MINERALS PROGRAM INSPECTION REPORT
PHONE: (303) 866-3567

MINE NAME: Robinson Sons Gravel Pit No. 1	MINE/PROSPECTING ID#: M-2008-076	MINERAL: Sand and gravel; borrow material for construction	COUNTY: Las Animas
INSPECTION TYPE: Monitoring	INSPECTOR(S): Amy Eschberger, Wally Erickson	INSP. DATE: November 23, 2016	INSP. TIME: 09:30
OPERATOR: Robinson Sons Inc	OPERATOR REPRESENTATIVE: None	TYPE OF OPERATION: 112c - Construction Regular Operation	
REASON FOR INSPECTION: Priority	BOND CALCULATION TYPE: None	BOND AMOUNT: \$52,815.00	
DATE OF COMPLAINT: NA	POST INSP. CONTACTS: None	JOINT INSP. AGENCY: None	
WEATHER: Clear	INSPECTOR'S SIGNATURE: 	SIGNATURE DATE: January 23, 2017

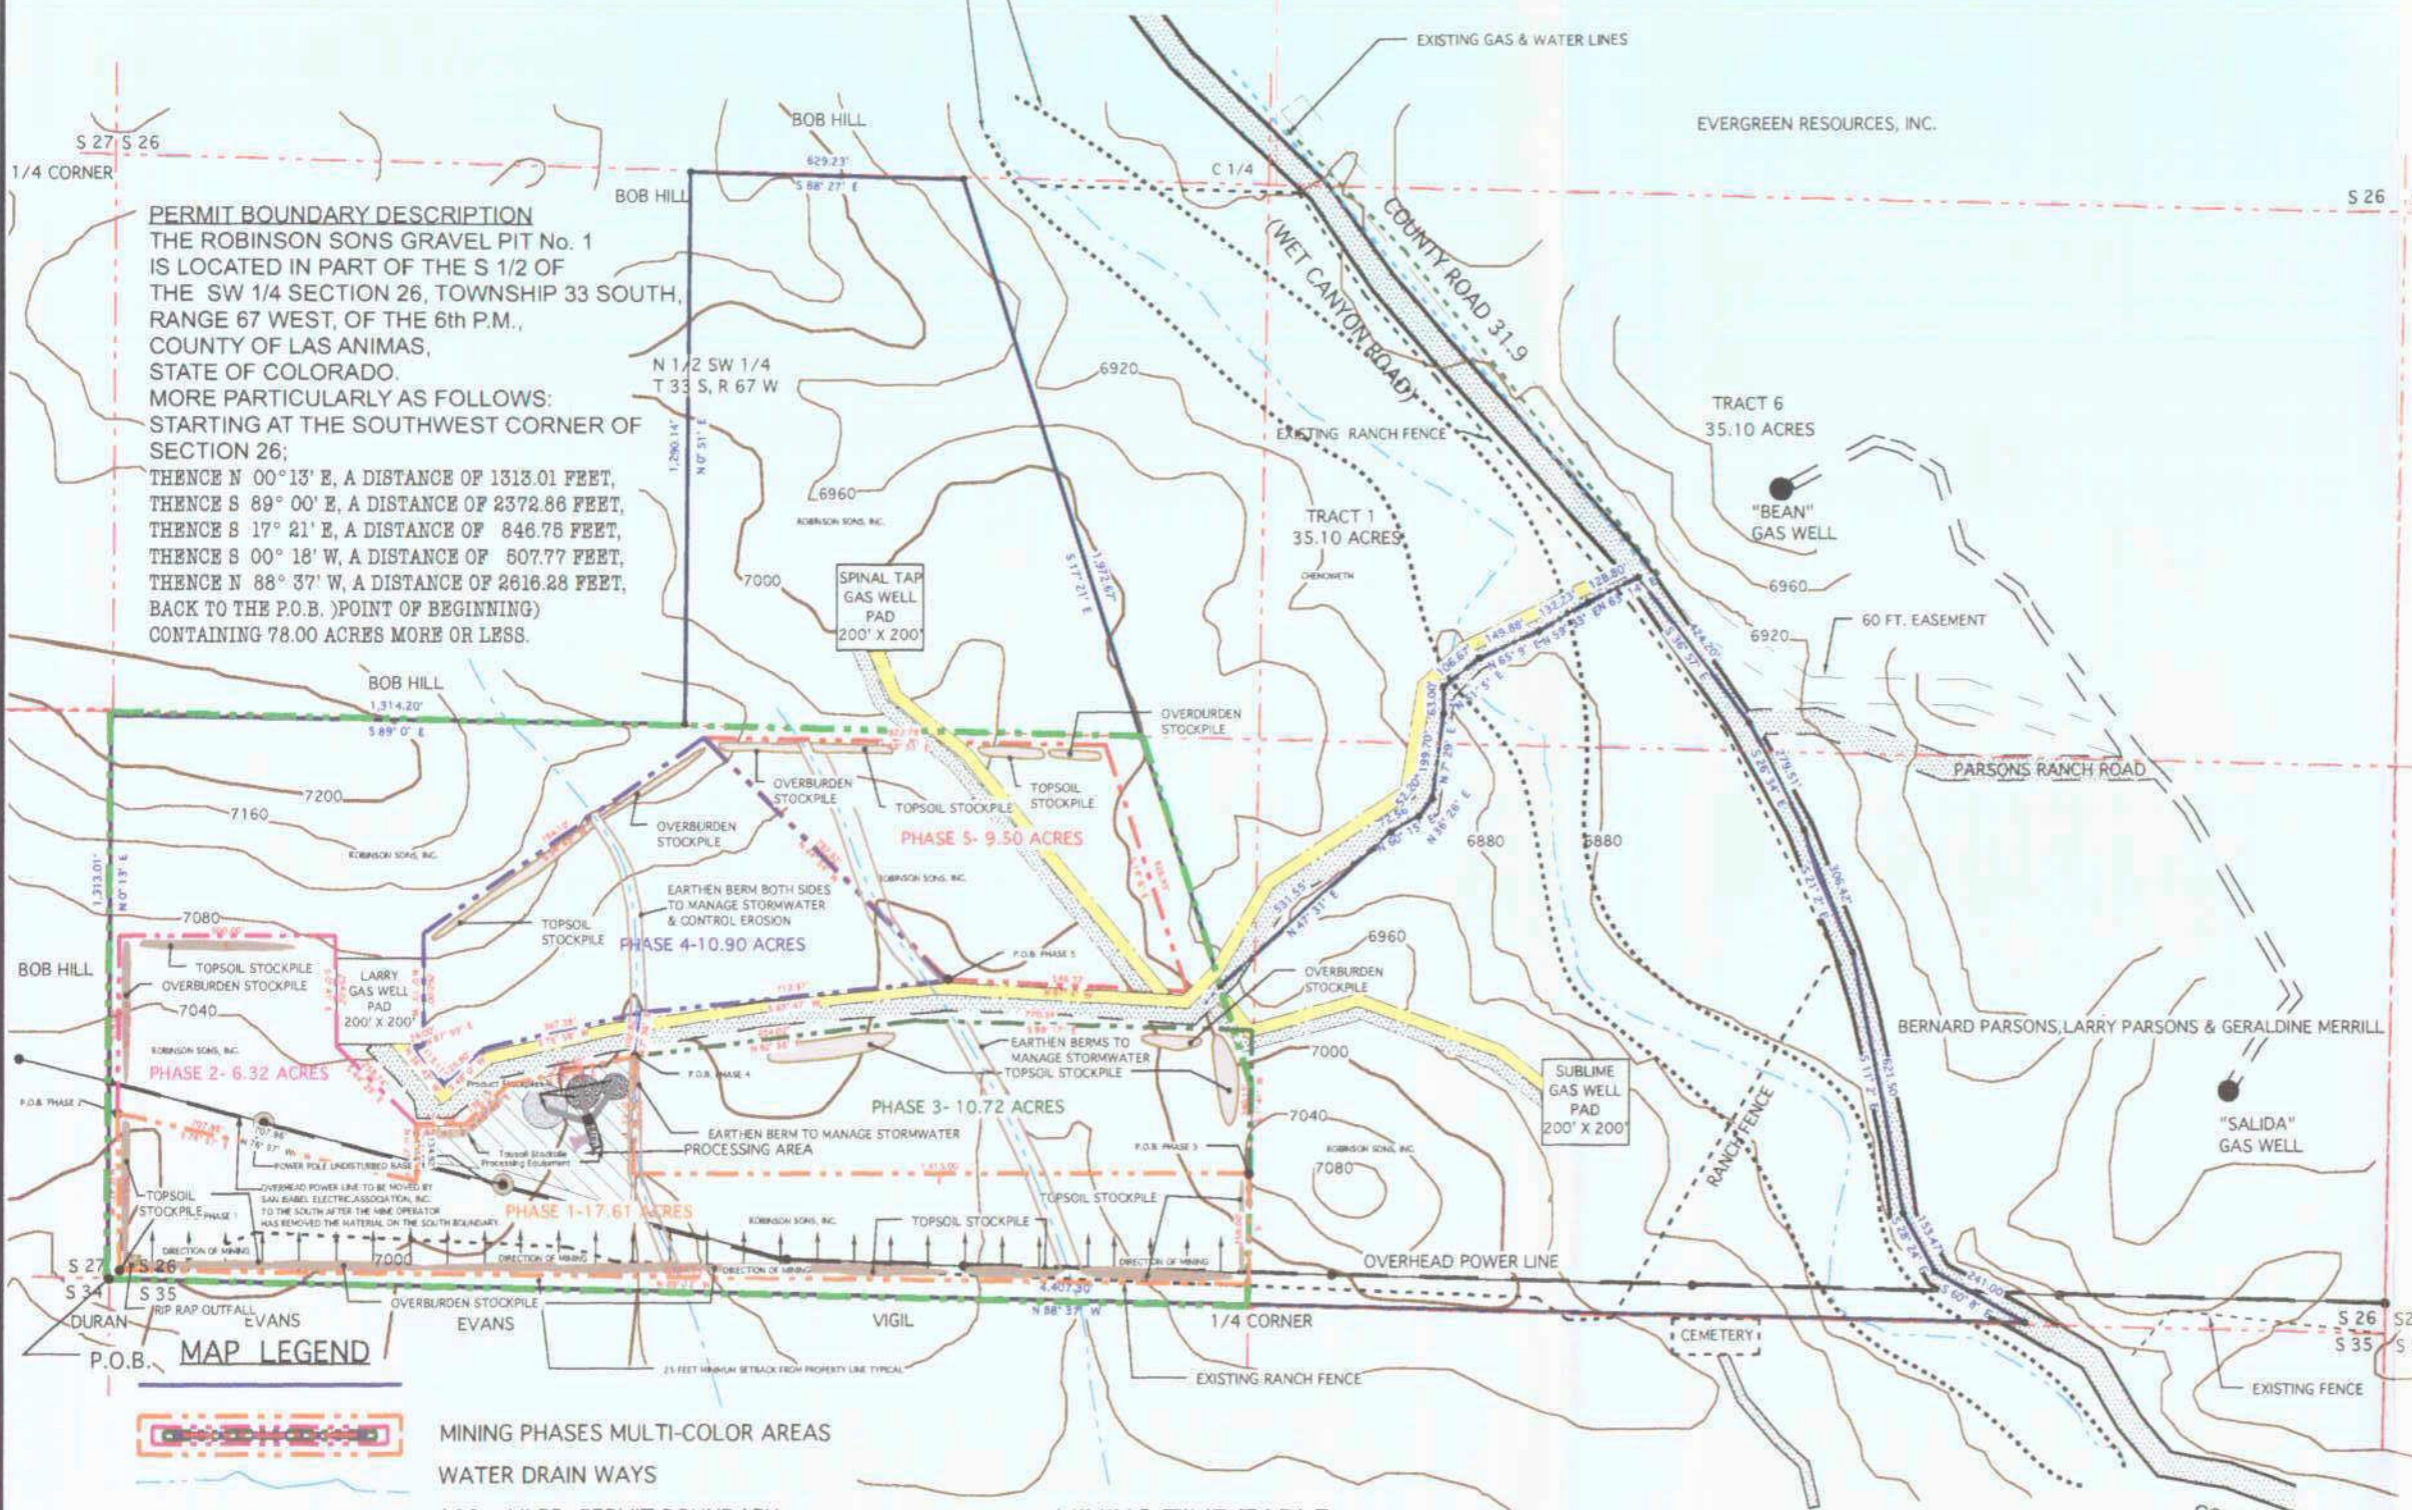
The approved permit maps delineate the southern permit boundary at the section line separating Sections 26 and

35 (see enclosed mining plan map). The existing ranch fence is identified on the maps as being located north of the section line and inside the permit area. Three property owners are identified to the south of the permit area, including Duran, Evans, and Vigil. However, it is not clear on the maps whether their properties begin at the fence line or at the section line (permit boundary). Therefore, on September 14, 2016, the Division sent an inquiry to Mr. Vigil, requesting a copy of the land survey referenced in his complaint. On September 22, 2016, the Division received copies of the requested survey (enclosed). Although the text on the copies is difficult to read, the survey appears to show that land between the historic fence and the section line is owned by Duran, Evans, and Vigil, and not the Operator. The Division estimates approximately 6.75 acres of land separates the fence from the section line. The Operator has not demonstrated a legal right to enter these 6.75 acres.

CORRECTIVE ACTIONS: Within 60 days of the signature date of this inspection report, due March 24, 2017, the Operator shall satisfy one of the following two options: 1) demonstrate a legal right to enter for the southern portions of the permit area described above, as required under Rules 6.4.14, 6.3.7 and C.R.S. 34-32.5-112(1)(c)(IV); Or 2) submit an acreage reduction request for these lands in accordance with Rule 4.17.
